Applicant: Kevin Walker; Beacon Interfaith Housing Collaborative
Consultant: Keith Matte; BKBM Engineers
Project: Vista 44 Multi-family Housing Development
Location: 13th Avenue South and 1st Street South: Hopkins
Rule(s): 4 and 5
Reviewer(s): LLH/BCO

General Background & Comments

1
C200
UTILITY PLAN
1" = 20'

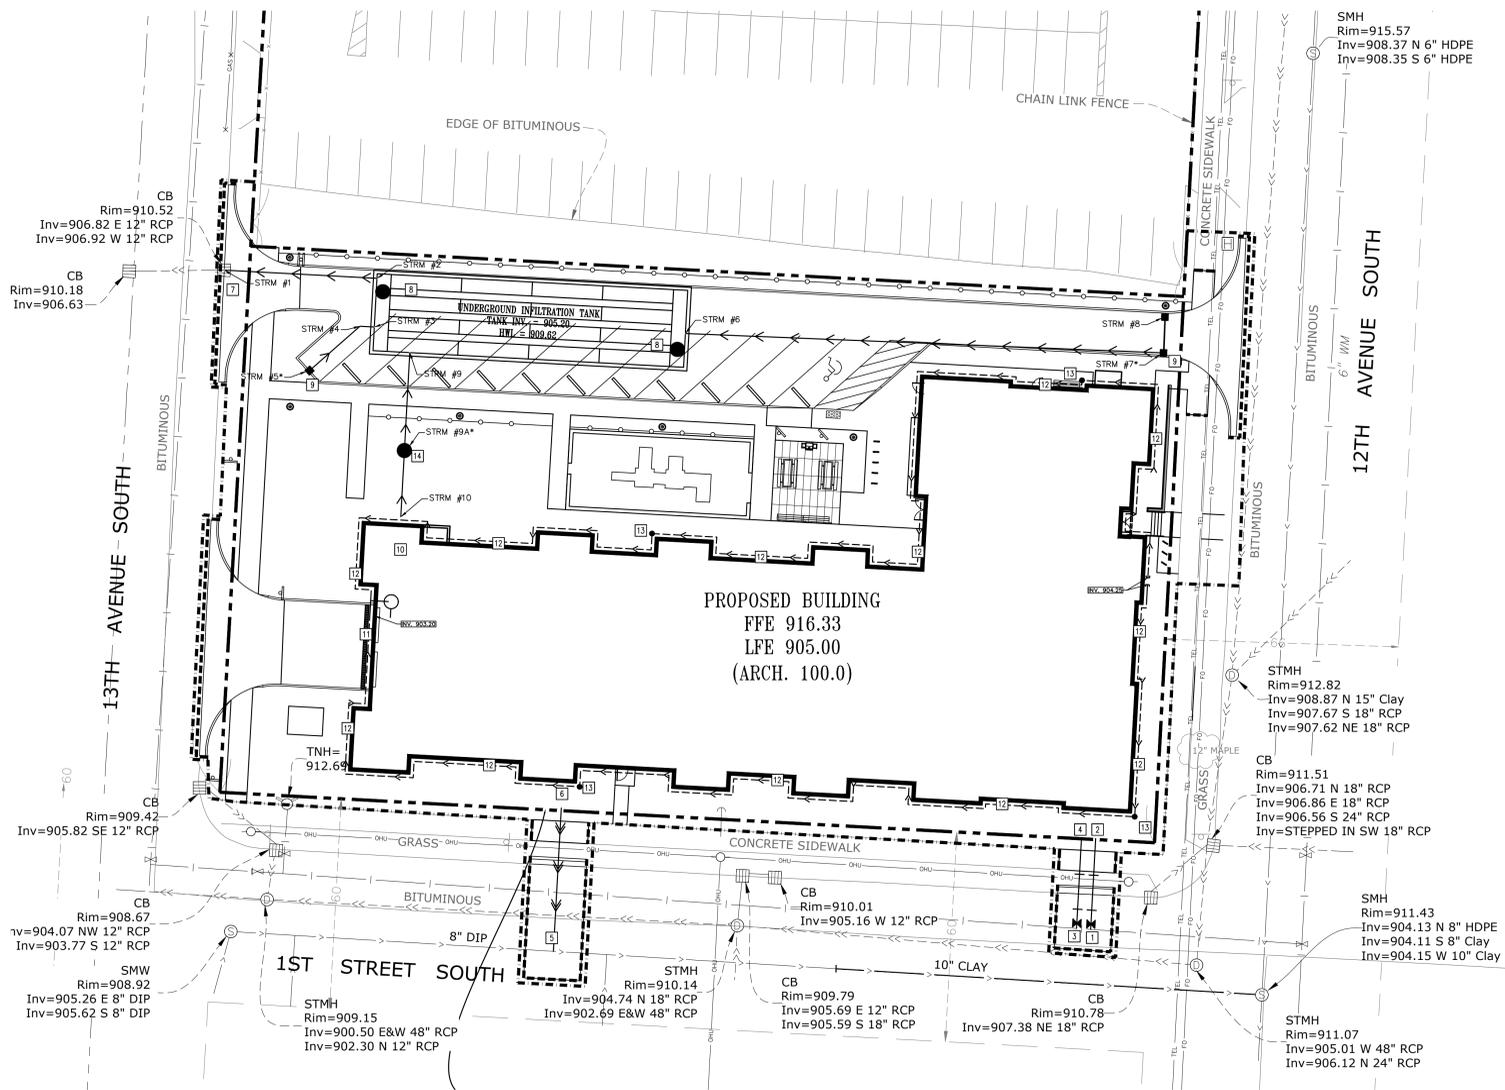
Stormwater management for compliance with Rule 4.3.1 will be provided by an UGSWMF located north of the proposed building beneath the surface parking area. The UGSWMF will provide rate control, volume retention and water quality management for the entire site. The UGSWMF will capture runoff from the proposed multi-family housing building roof, surface parking lot and landscaping. A portion of stormwater runoff from landscaping and impervious surface will drain west towards 13th Ave S.

Rule 4.5.4d (i) requires at least three feet of separation between the bottom of a stormwater management facility and groundwater. The boring taken by NTI near the proposed UGSWMF location encountered groundwater at a depth of 9.4 feet, elevation 901.6 M.S.L. The proposed bottom elevation of the UGSWMF is 904.7 M.S.L., providing a separation of 3.1 feet between

the bottom of the proposed facility and the elevation where groundwater was encountered. In accordance with Rule 4.5.4d, the required three feet of separation between the bottom of an infiltration area and groundwater is provided.

In accordance with Rule 4.3.1a (i), where infiltration facilities, practices or systems are proposed, pre-treatment of runoff must be provided. Sump manholes will provide pretreatment for runoff entering the UGSWMF. Rule 4.3.1a (i) is met.

A receipt showing recording of a maintenance declaration for the on-site stormwater management facility. A draft of the declaration must be approved by the District prior to recordation.

Per Rule 4.5.8, submit an as-built drawing of the stormwater management facility conforming to the design specifications, including a stage volume relationship in tabular form for the stormwater management facility.
